In the Drawings

REMARKS

The Office Action mailed May 17, 2006 has been carefully considered. Reconsideration in view of the following remarks is respectfully requested.

FIG. 2

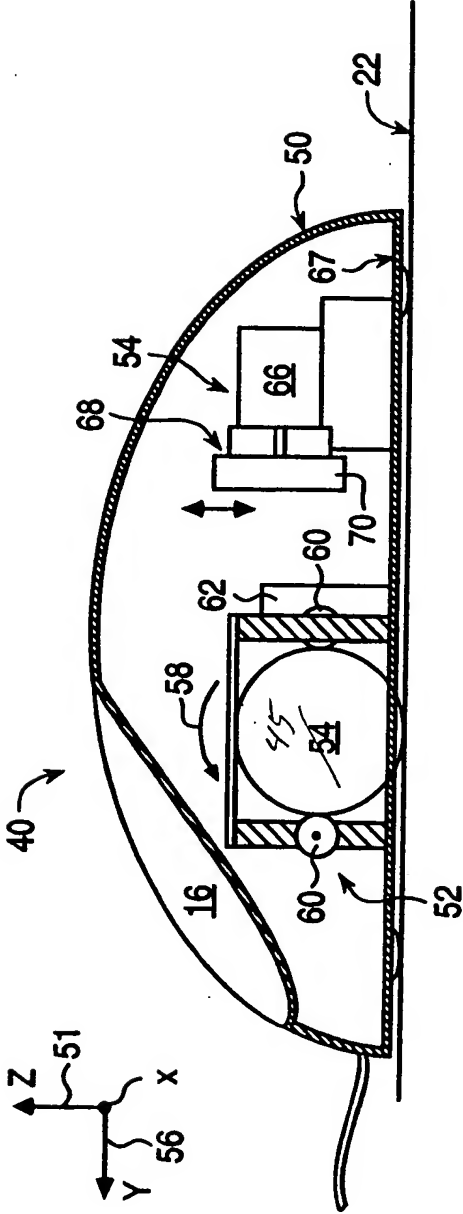
FIG. 2 has been amended to change the reference designation of the trackball to “45,”
consistent with the specification.

FIG. 2 has been amended to change the reference designation of the trackball to "45," consistent with the specification.

The specification has been amended on page 11 in order to be consistent with the correction to FIG. 2, in which the reference numeral of the trackball has been changed "45" for consistency with the remainder of the specification.
